THE CORPORATION OF THE CITY OF RICHMOND HILL

Addendum # 7

RFQ-2510155

Connor Building Renovation and Retrofit

See below new detail 8/A102.2 re proposed separation to allow for drainage between the fabric roof structures. This configuration is common throughout the province.

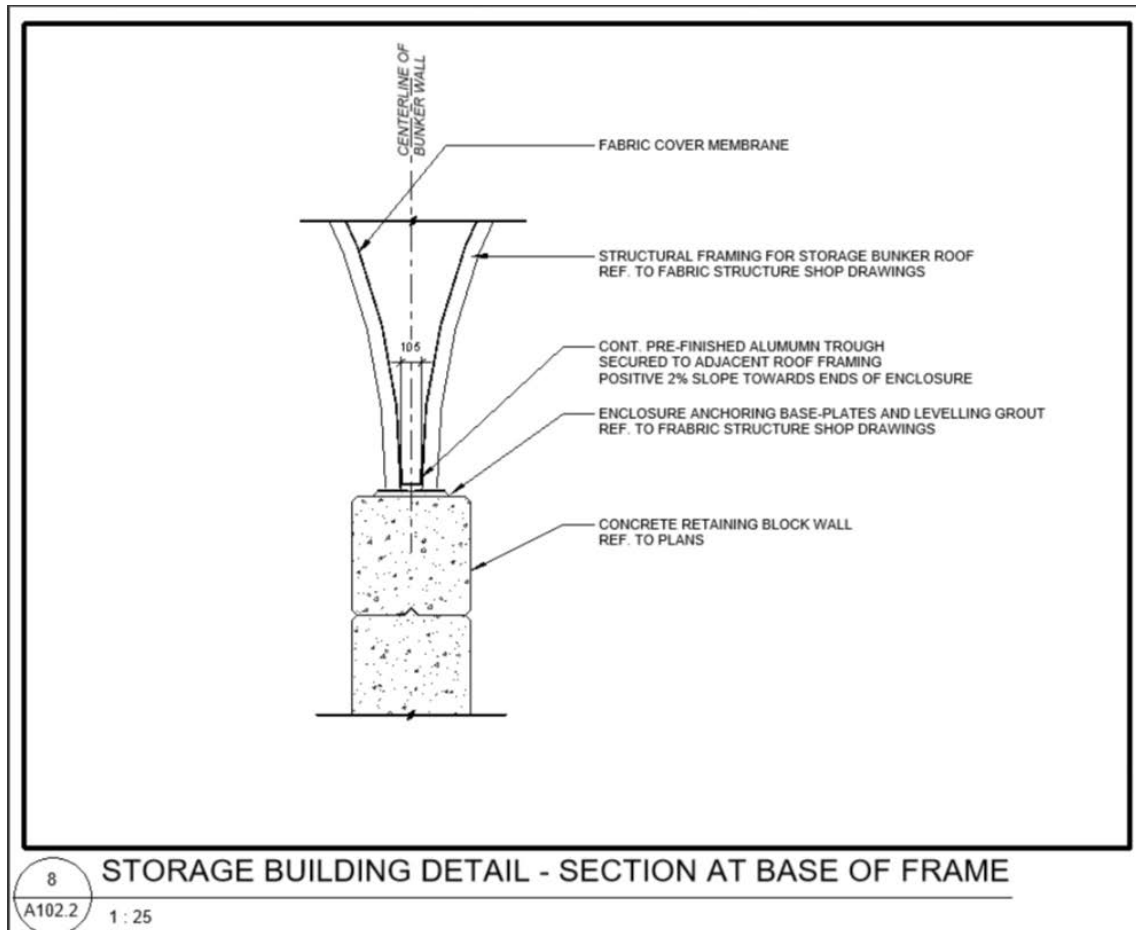
Add. #5 reviewed, two comments came back immediately from two specified suppliers for fabric structures regarding the multi dome design;

- We cannot find someone willing to design this particular structure, and we cannot provide a bid.
- We have concerns with this design, in addition to snow and water build-up (there is nowhere for it to go, it must go between and it will seep into the bunks), there is also the fact that the structures are 1' apart and may require a fire separation. Why not do one structure 80' long.
